Report to Development Unit

SUBJECT: N0799/04 - 13 Bruce Street, Warriewood - Demolition of Existing Structures and Construction of New House, Garage and Swimming Pool

Date: 17 February 2005

SITE PLAN SCALE 1:300

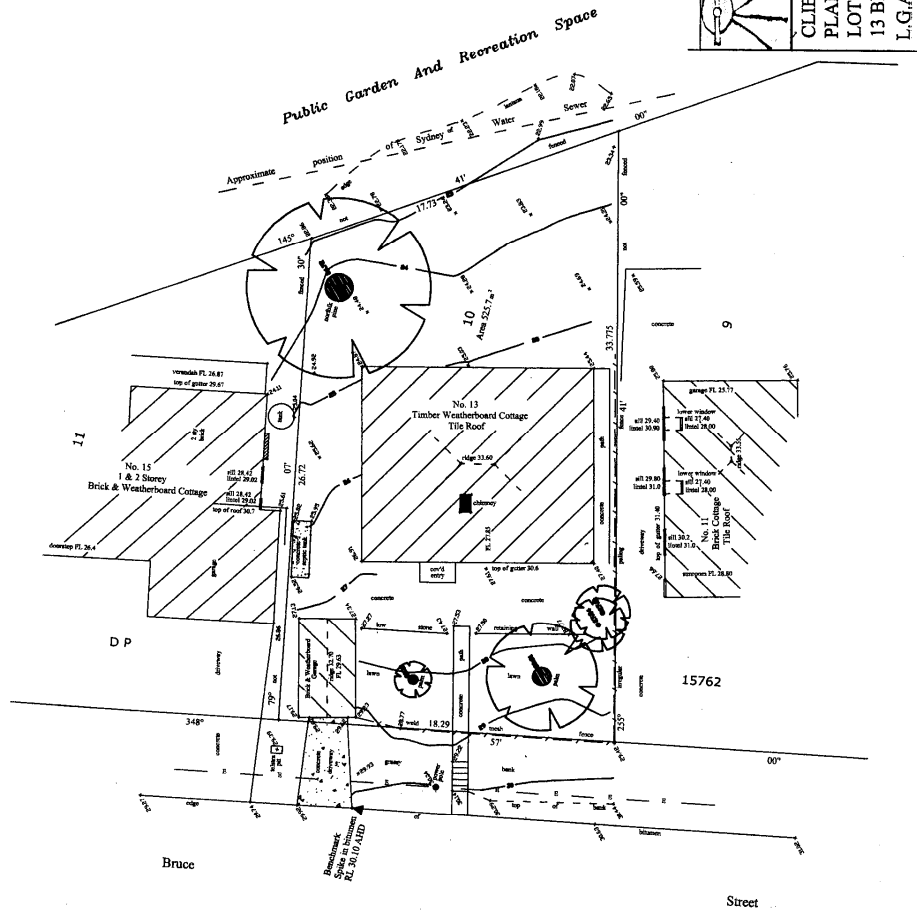
The proposal is to demolish the existing house and detached garage and to construct a new house, attached garage and swimming pool. It is proposed to provide a new double garage in front of the new house, in the south western half of the street frontage, on a nil setback and entirely within the front building setback.

3. The building rear wall, verandahs and the retaining wall have been set back farther from the Norfolk Pine Tree. The rumpus room setback has been increased from 2.8m to 4.1m from the tree and all of the development now complies with a 6.5m rear boundary setback.

5. The swimming pool now complies with a 6.5m front boundary setback and the front wall setback has been increased from 600mm to 1000mm at the northern end and 1m to 1.4m at the southern end. The entry is set back and the garage is set back a further 200mm to 1m at the southern end. The garage width has been reduced by 500mm to 6.5m.

It is proposed to provide a new attached double garage in front of the house (south western half of the street frontage) entirely within the front building setback, however, this minimizes driveway area to under 5sqm, which is a creditable reduction in paved area.

However, objection is raised to the proposed driveway configuration. A condition (B9) is proposed that states "*The driveway width is to be reduced to 4m at the kerb*", not the 7m as proposed. All relevant comments have been considered and incorporated as conditions in the recommendation.

B9. The driveway width is to be reduced to 4m at the kerb.

- B44. No part of the foundations, building perimeter, or any projecting structure is to be positioned within a distance of 4m from the trunk of the Norfolk Pine Tree (T3). Details to be shown as amendments in the Construction Certificate application.

SURVEY PLAN SCALE 1:200

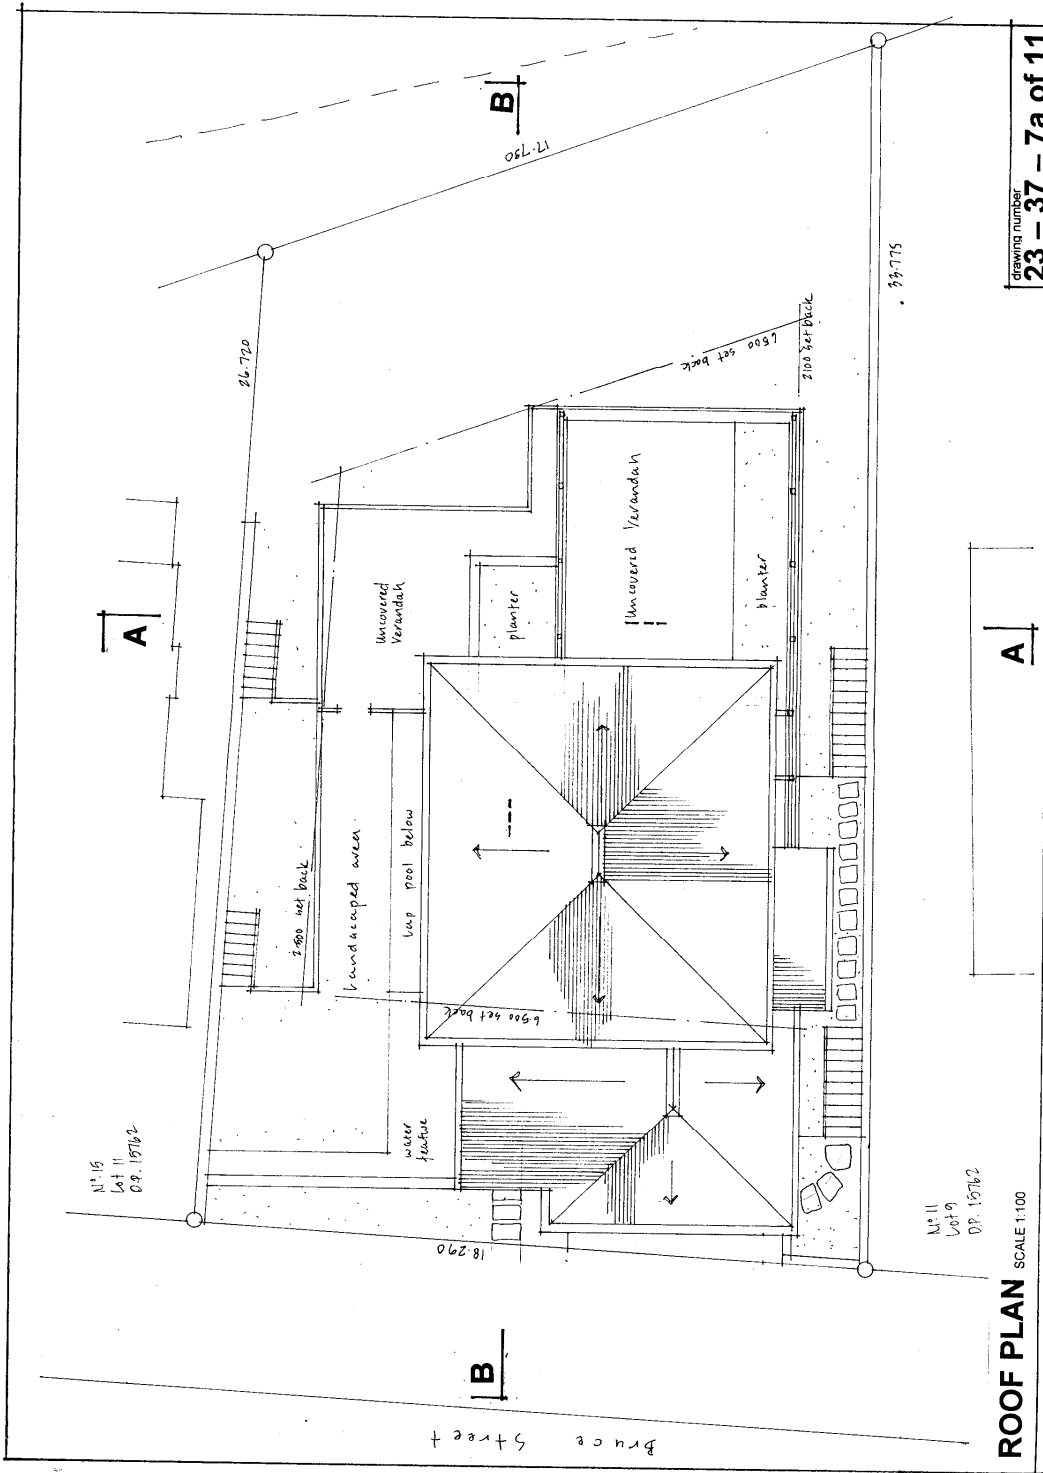
- D108. In accordance with Pittwater Council's Tree Preservation and Management Order, all existing trees as indicated on [Survey Plan No 23-37-2](#) shall be retained except where Council's prior written consent has been obtained, or where after approval of the relevant Construction Certificate Application/s, trees stand within the envelope of approved buildings or within the alignment of approved permanent paved vehicular access roads and parking areas.
- D122. All declared noxious weeds under the Noxious Weeds Act 1993 together with other environmental weeds are to be removed and/or controlled using an appropriate technique.

- D197. In accordance with Pittwater Council's Tree Preservation and Management Order, all existing trees as indicated on **Survey Plan No 23-37-2** shall be retained except where Council's prior written consent has been obtained, or where after approval of the relevant Construction Certificate Application/s, trees stand within the envelope of approved buildings or within the alignment of approved permanent paved vehicular access roads and parking areas.
